**Subject: Revision 1 of the Final Closure Report
Non-Asbestos-Containing On-Site Landfill
Permit Exempt “815” Facility #0971900014
Johns Manville, Waukegan, Lake County, Illinois**

Non-Asbestos Containing On-Site Landfill Construction Final Closure Report - State Facility ID# 0971900014

Revision 1

Response 06: Relocated Barrier Material Drawing

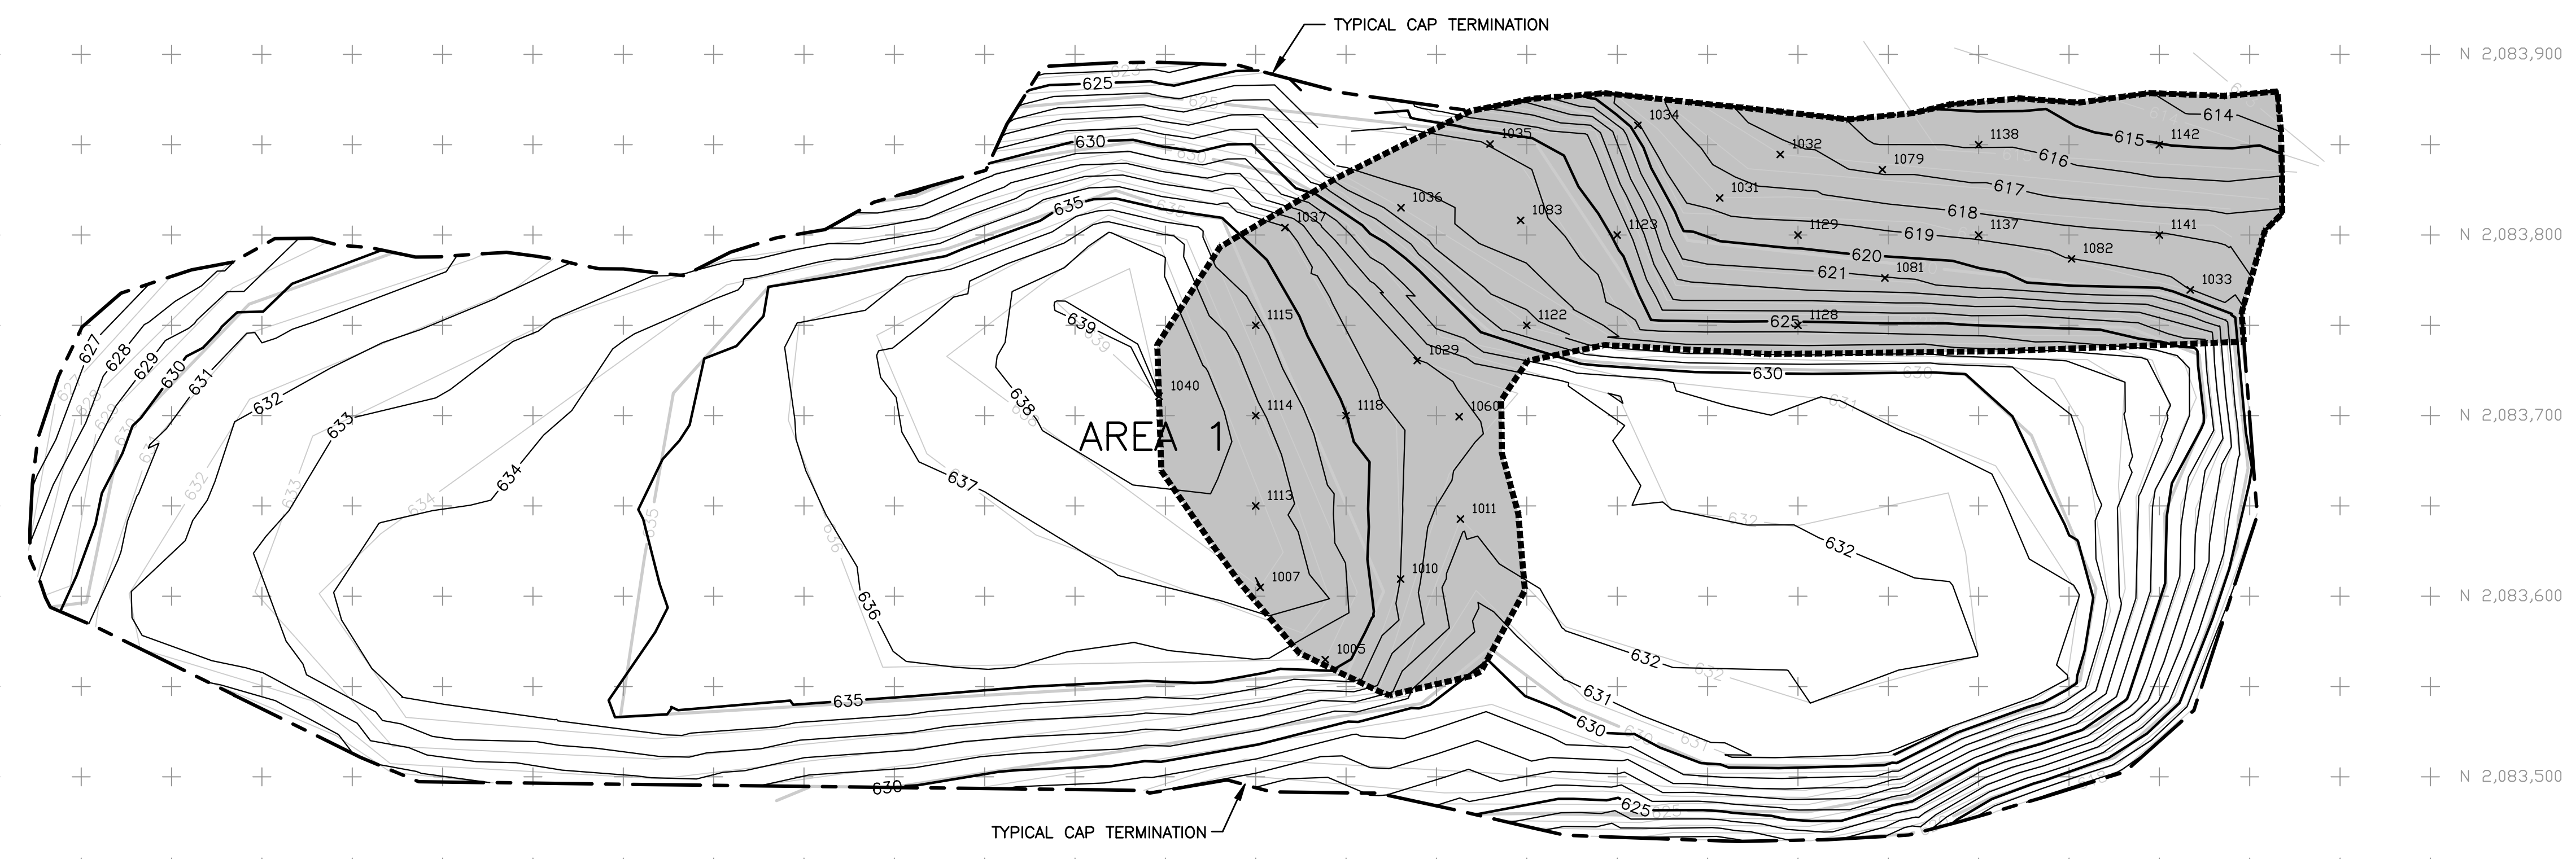
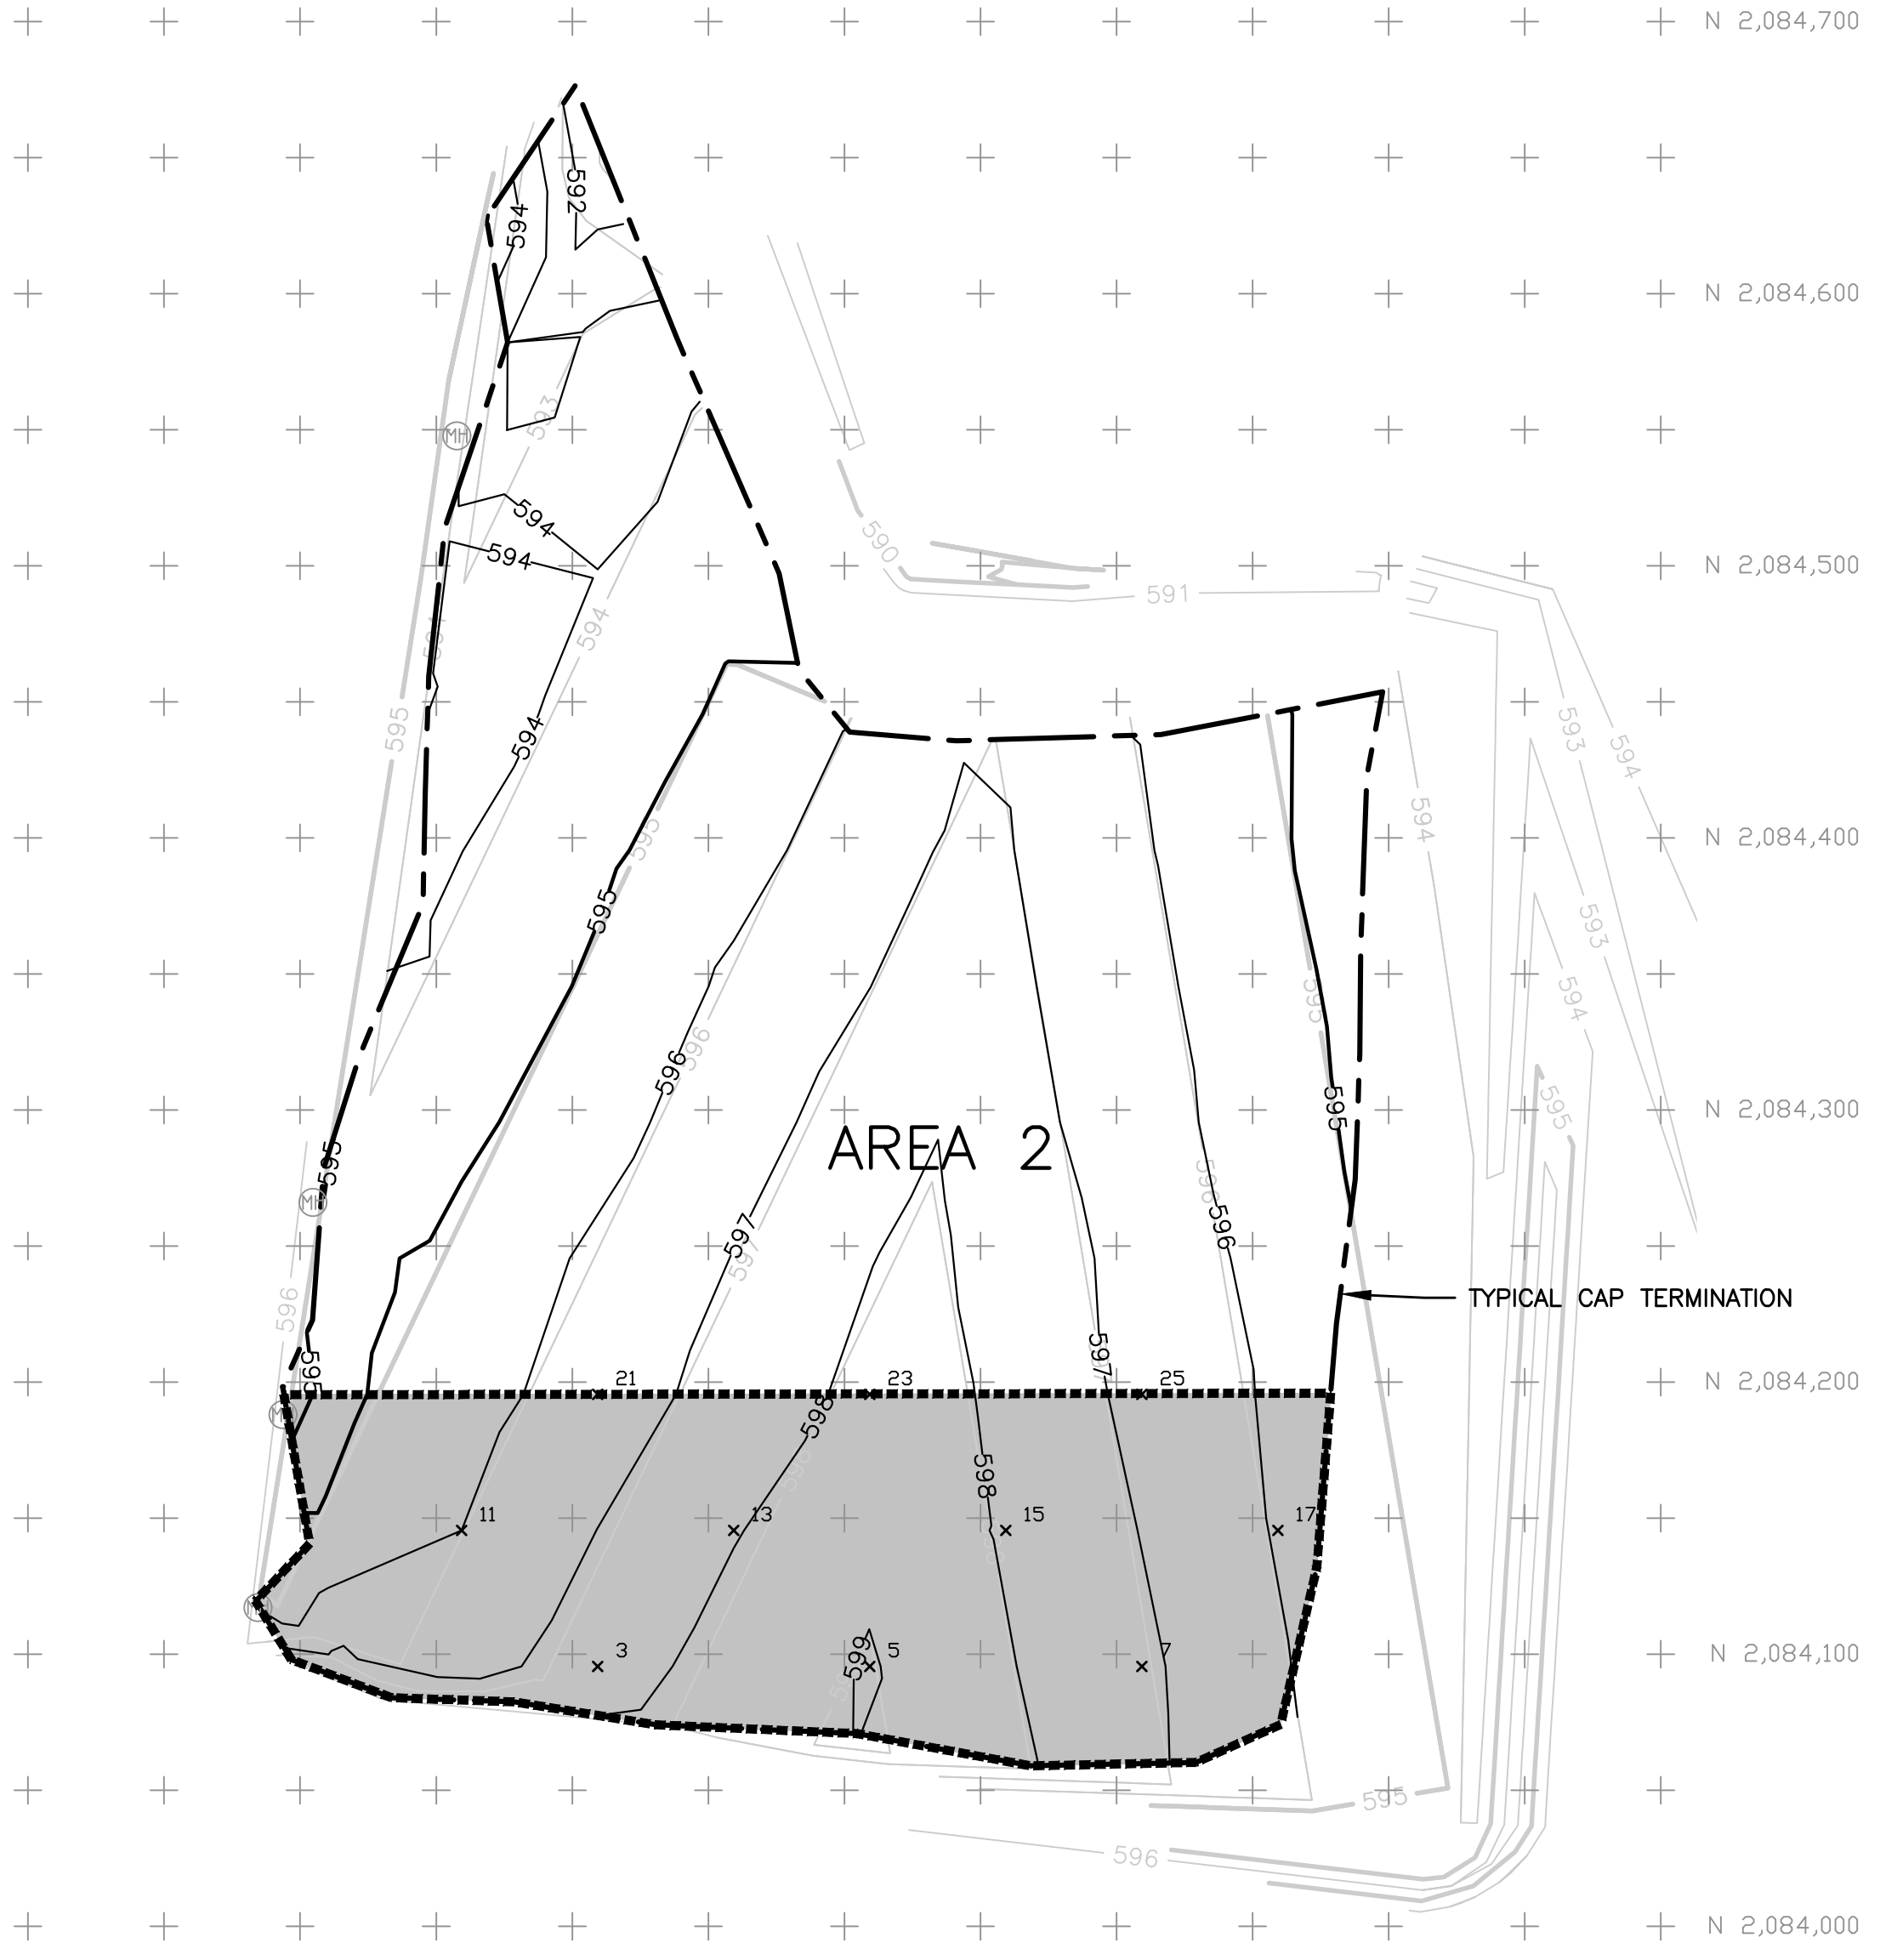
Comment 06: It is recommended that the CCR explain or provide the reference that describes the origin as well as the environmental and geotechnical quality of the Lake County clay used for the interim material layer that comprises the existing clay for the construction of large portions of the barrier layer. In addition, the report needs to provide the procedure used for surveying and determining the approved "Design Barrier Elevations" in Construction Drawing A-4 in the CCR for the different points and coordinates. Ultimately, the closure report should provide confirmation that the thickness of the barrier layer was a minimum of one foot and corresponded with the procedure and geotechnical information described in the approved RWP. The report also needs to verify that the site preparation and barrier layer construction procedures were in accordance with the RWP, and show the details regarding the areas where the Barrier Layer material for Fill Areas #1 and #2 was constructed, compacted,

1. FILL AREA 1 CLAY RELOCATION AREA = 105,114 SQUARE FEET.
2. FILL AREA 2 CLAY RELOCATION AREA = 46,230 SQUARE FEET.
3. BARRIER THICKNESS TESTING FREQUENCY >1 SAMPLE/5,000 SQUARE FEET.
4. BARRIER THICKNESS TESTING COMPLETED BY AECOM ON AUGUST 15 AND 16, 2018 USING A GEOPROBE.
